PRODUCT/PROCESS CHANGE NOTICE (PCN)

PCN #: TB-0609-03 DATE: 06-Oct-2006 Product Affected: All square PQFP and TQFP, MLP Dual, QFP-N, VFQFP-N packages shipped in Tape and Reel Date Effective: 06-Nov-2006	MEANS OF DISTINGUISHING CHANGED DEVICES: <input type="checkbox"/> Product Mark <input type="checkbox"/> Back Mark <input type="checkbox"/> Date Code <input checked="" type="checkbox"/> Other Starting 06-Nov-2006
--	---

ATTACHMENT I - PCN #: TB-0609-03

PCN Type: To comply to current EIA Standard (EIA-481-C) requirement.

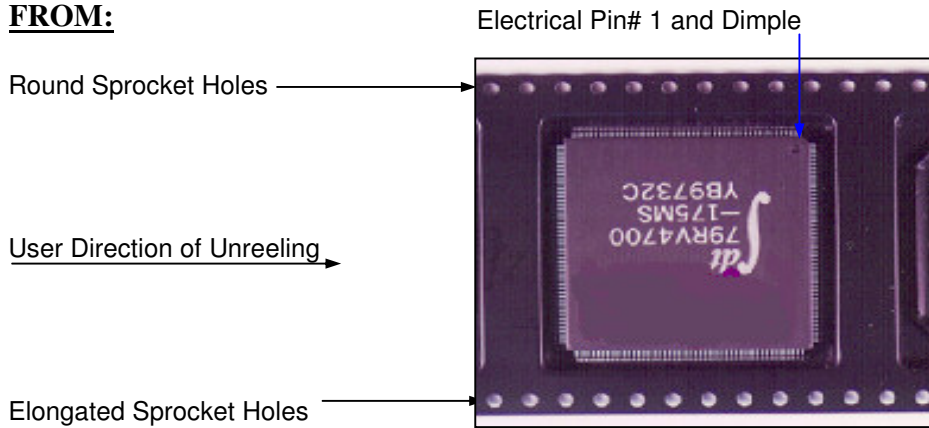
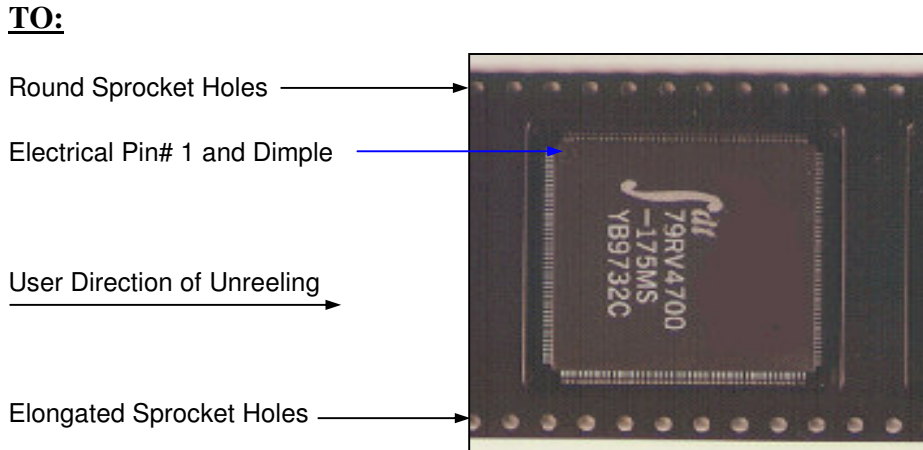
<input type="checkbox"/> Die Technology <input type="checkbox"/> Wafer Fabrication Process <input checked="" type="checkbox"/> Assembly Process <input type="checkbox"/> Equipment <input type="checkbox"/> Material <input type="checkbox"/> Testing <input type="checkbox"/> Manufacturing Site <input type="checkbox"/> Data Sheet <input checked="" type="checkbox"/> Other - Packaging	Pin 1 orientation of all square PQFP and TQFP, MLP Dual, QFP-N and VFQFP-N packages shipped in Tape and Reel packaging will be changed to comply with current EIA Standard (EIA-481-C) requirement. Additional label will be placed on the intermediate box (pizza box) to alert customer of this change. Please see attachment for details.
---	---

Detail of Change: This change will be implemented on all square PQFP and TQFP, MLP Dual, QFP-N, VFQFP-N packages.

FROM:

TO:

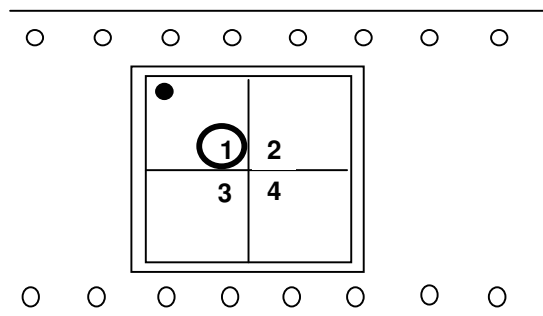
Additional label as shown below will be placed on the intermediate box (pizza box) to alert customer of this change. Label will be placed starting 06-Nov-2006 until 06-Nov-2007. However, please take note that IDT will continue to ship products in existing loading orientation until the inventory has been depleted. Customer may receive shipments in existing or new loading orientation.

● Pin One in Quadrant 1
